I.1.b.b 2708 Graham Street and 1050-1054 Hillside Avenue - Development Permit with Variances Application No. 00043 (Hillside/Quadra)

Committee of the Whole Report

Subject: **Development Permit with Variances Application No. 00043 for 2708 Graham Street and 1050-1054 Hillside Avenue**

1 Front Elevation (South)

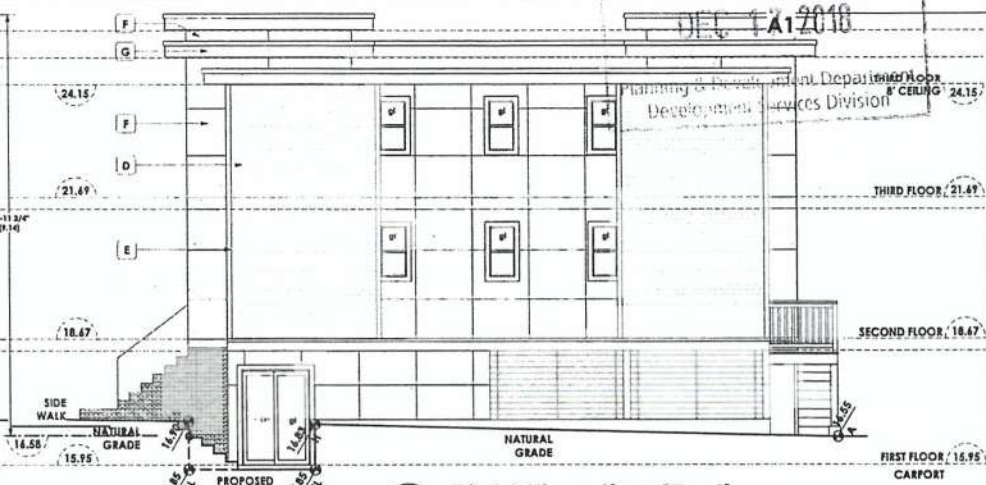
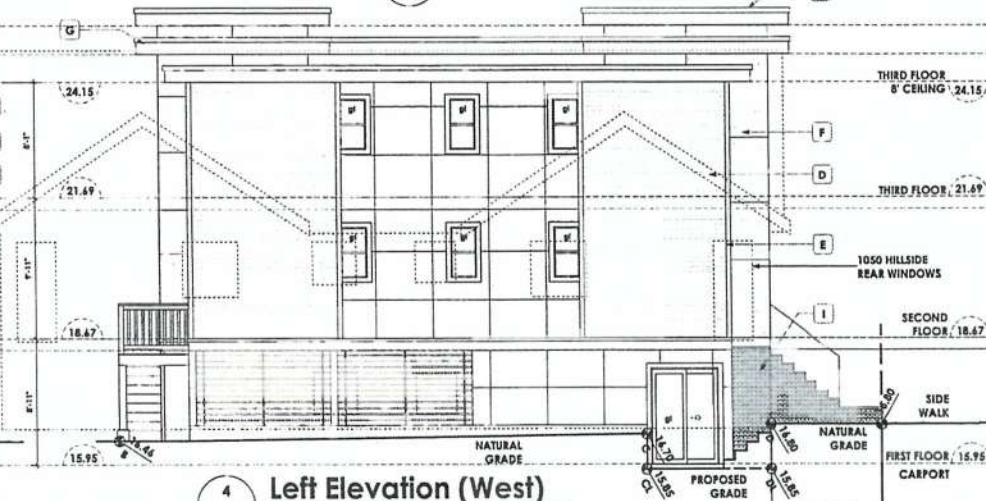
Staff believe further improvements can be made to the proposal. Revising both the horizontal metal siding and the glass garage door to wood would soften the appearance of the proposal and de-emphasize the prominence of the vehicle entrance. Adding canopies to the residential entrances would further increase the prominence. Additionally, the bicycle parking is shown differently on the site plan and the landscape plan; the landscape plan should be revised to match the site plan. These proposed changes have been added to the staff-recommended Council motion.

3. Revised plans, to the satisfaction of the Director of Sustainable Planning and Community Development, to add canopies above the townhouse front doors, change the horizontal metal siding to wood, amend the landscape plan bicycle parking to be consistent with site plan, and change the garage door to wood.
